ADDRESSEES	: Owners and operators of coaches listed under “Application” ABC Customer Care and Parts Source
VEHICLE MODEL	: CX45 MY2023
MANUAL CHAPTER	: 10.54. Body and accessories – Body structure
BULLETIN TYPE	: Field change program
DATE	: May 10 th 2023
SUBJECT	: To support lower cross bar and change gas springs of radiator compartment access door
CONDITIONS	: Refer to chapter “Warranty” further on in this bulletin.

DESCRIPTION

Figure 1: Location of cross bar at the bottom of the radiator compartment

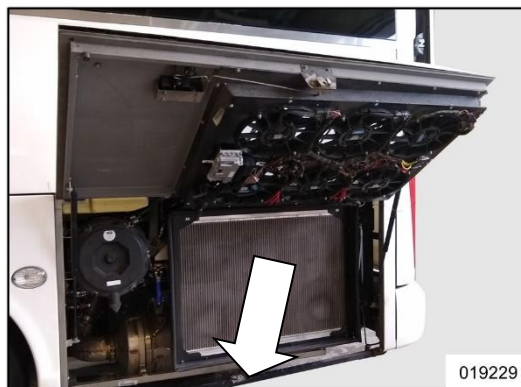
Van Hool has received some complaints about the unintended unlocking of the radiator compartment access door while driving. Investigation has shown that this issue is caused by a lack of rigidity of the cross bar (containing the lock catcher) at the bottom of the compartment. To address this issue, Van Hool is conducting a field change program whereby the affected cross bar will be supported by an extra bracket and the gas springs of the compartment access door will be replaced with a more powerful type. This service bulletin gives step-by-step instructions to this end.

Figure 2

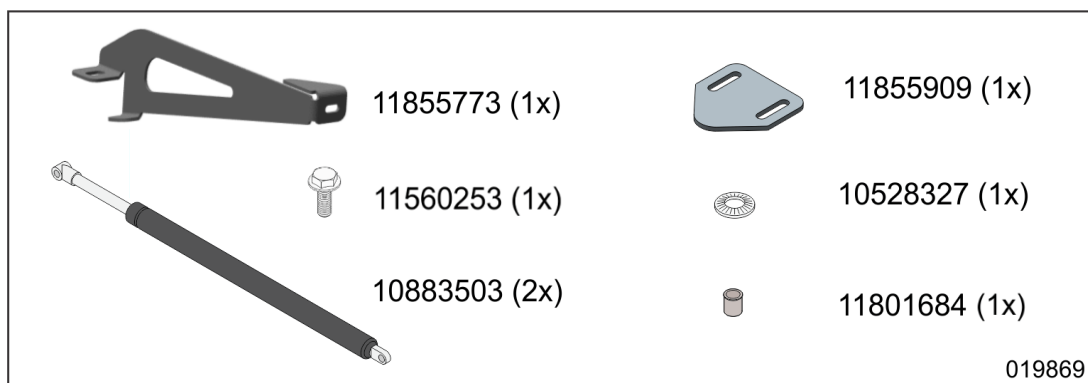
Parts of retrofit kit VH11862124
